Resource Insight Inc.
MEMORANDUM

Date: February 14, 2020

Subject: Input on Draft Assumptions Set

Figure 1: Solar PV Cost Projections

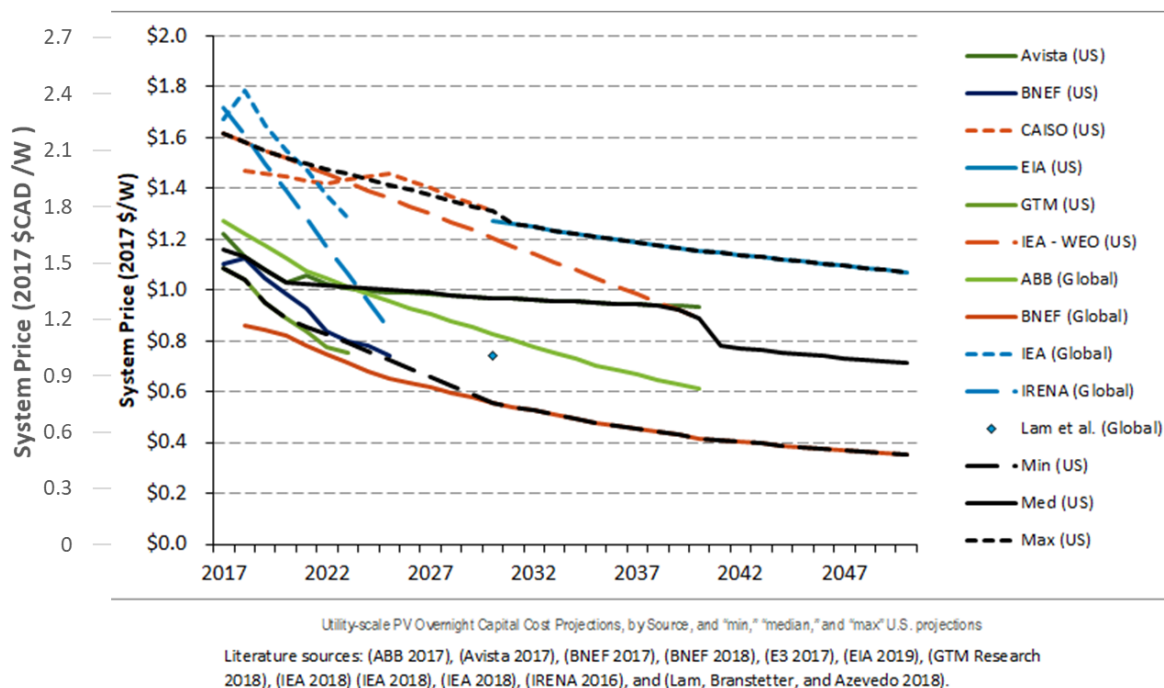
According to the US NREL Annual Technology Baseline for solar PV, the capital cost estimate of \$2,250 / kW is inconsistent with all but a few very high recent estimates. ⁷ As shown below, those forecasts showing similar costs in 2019 were

(a) generally created over two years ago and (b) associated with rapidly declining costs.
